SJRWMD and SWFWMD Responses to Stakeholder Comments on the Draft Central Springs Groundwater Flow Model (CSM) version 1.0

January 31, 2024

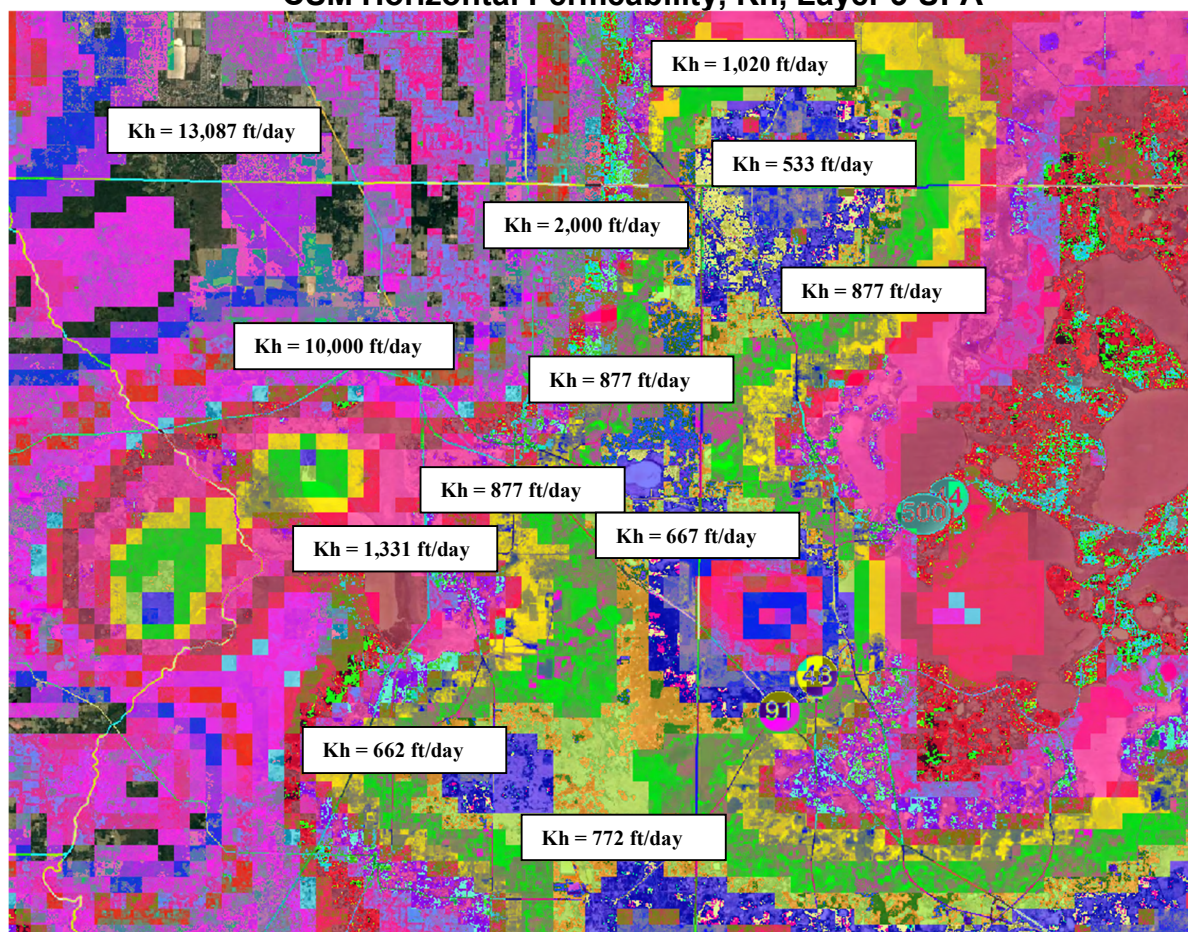
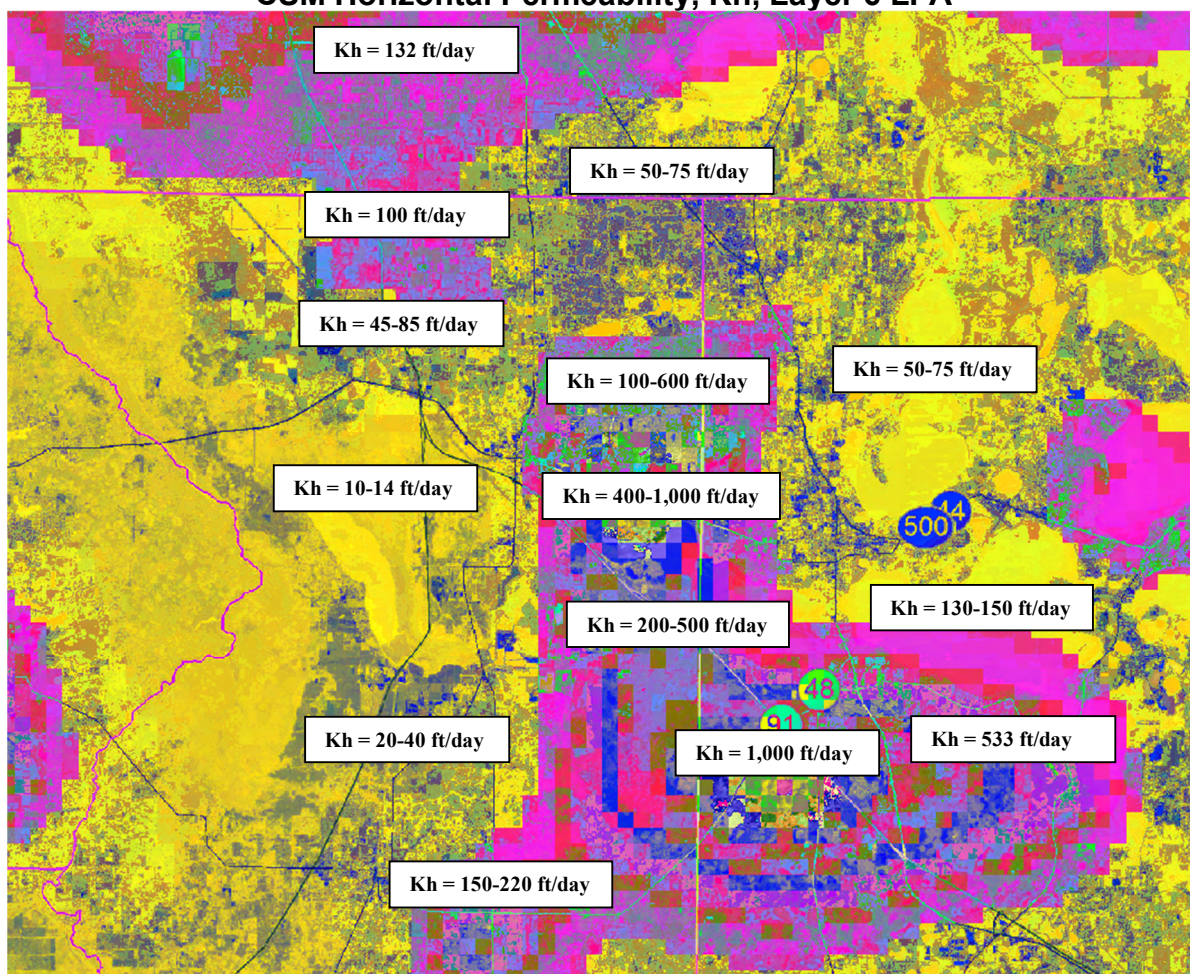
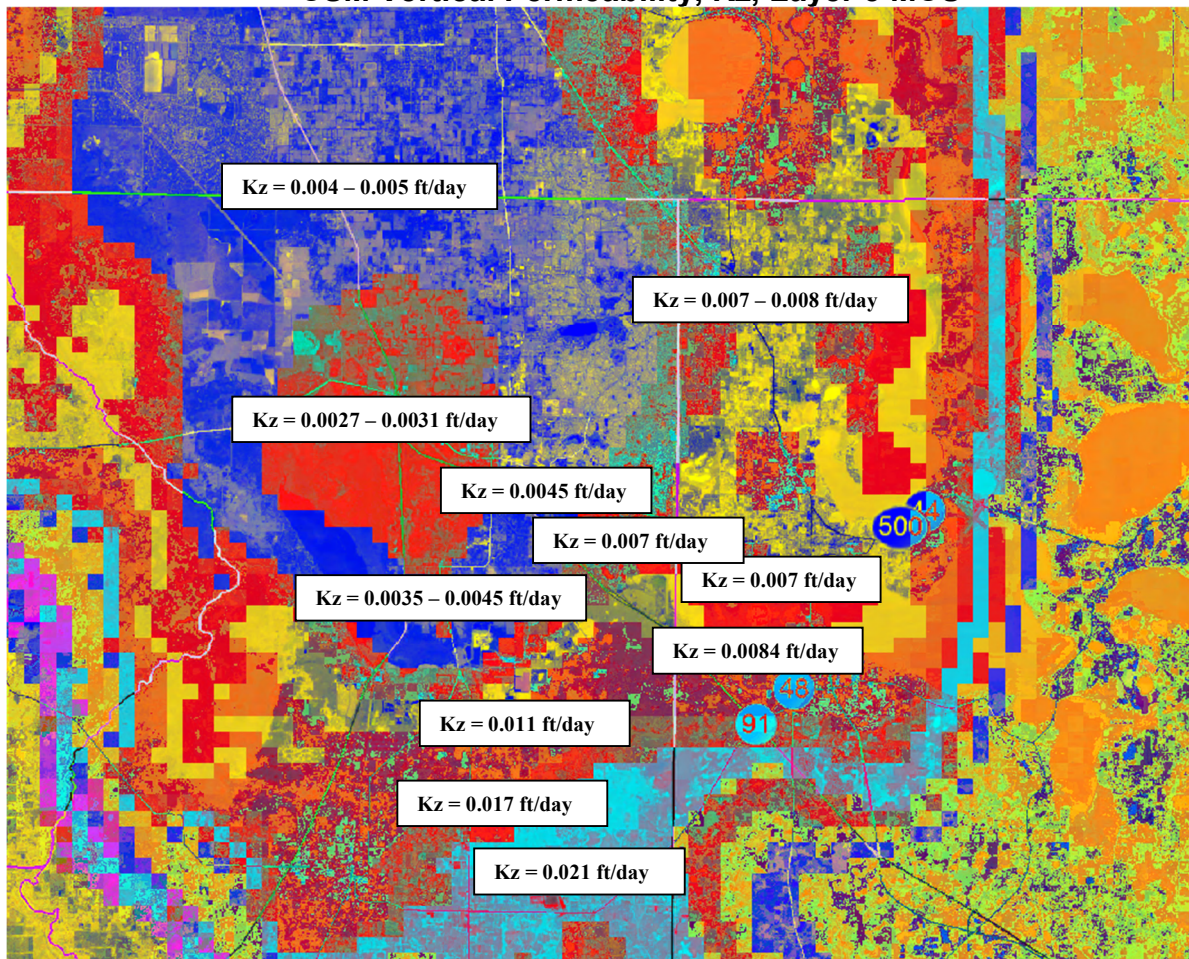
The data presented in the figures above indicate drastically different horizontal and vertical permeability values of the CSM model as compared to the recently expanded and recalibrated NDM5 model. The horizontal permeability values in the UFA, although extremely variable, appear to simulate the potentiometric surface reasonably well, except in the central-west area of The Villages. However, the horizontal permeability of Layer 6 (LFA) appears to be very low in the north and western portions of the area of interest and does not compare well with the recently recalibrated NDM5 model.

Response: The horizontal transmissivity of the UFA and LFA in the CSM is in reasonable agreement with values in the expanded NDM5. Limited data was available for the vertical permeability of layer 5 (MCU). As part of the CSM v1.1 modeling effort, further refinement of localized aquifer parameters, including consideration of values from APT tests and from the expanded NDM5, will be undertaken to enhance the model representation around the Villages Development.

FIGURE 2

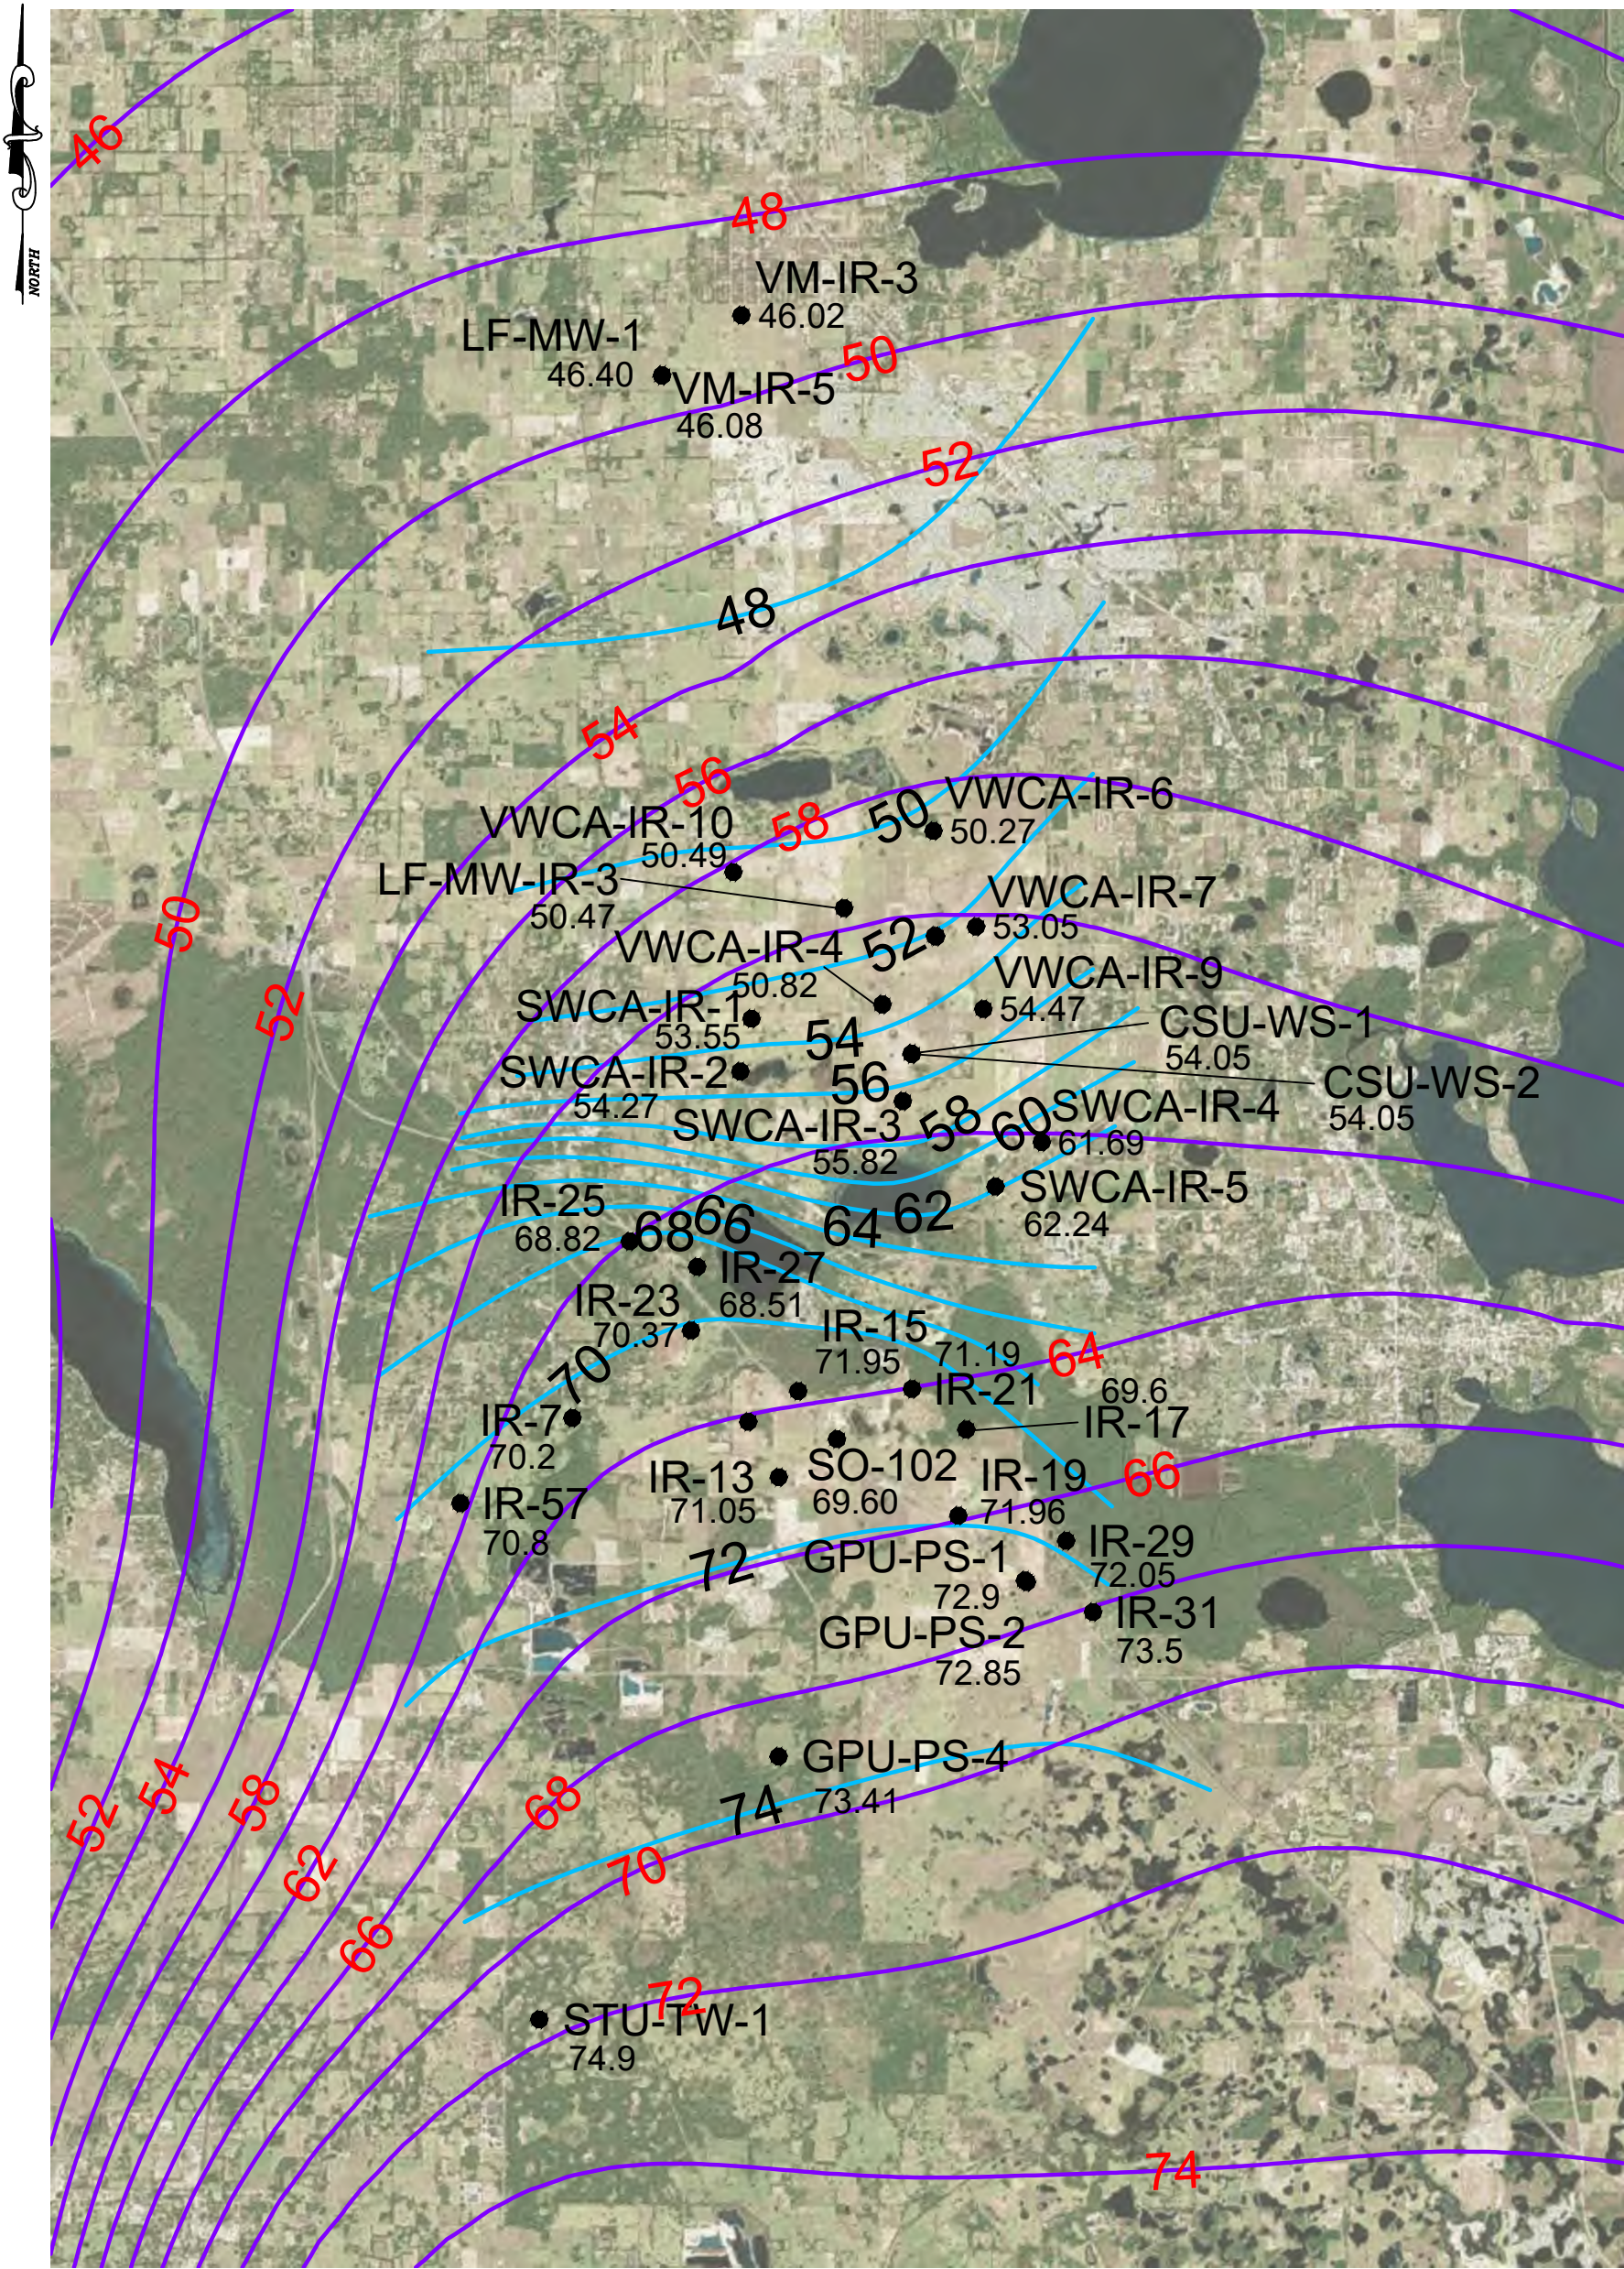
Comment #6 (AEI): *The CSM calibrated potentiometric elevations of the LFA are significantly off for the entirety of the Villages Development, most notable in the southern expansion area (area of interest) where the difference is as high as 8 ft. [see Figure 2 in Appendix, AEI report]*

Response: The LFA potentiometric surface simulated by the CSM was in general agreement with the observed regional groundwater level. Localized adjustments will be performed in the Villages Development area to enhance the representation of the LFA as part of the CSM v1.1 modeling effort.
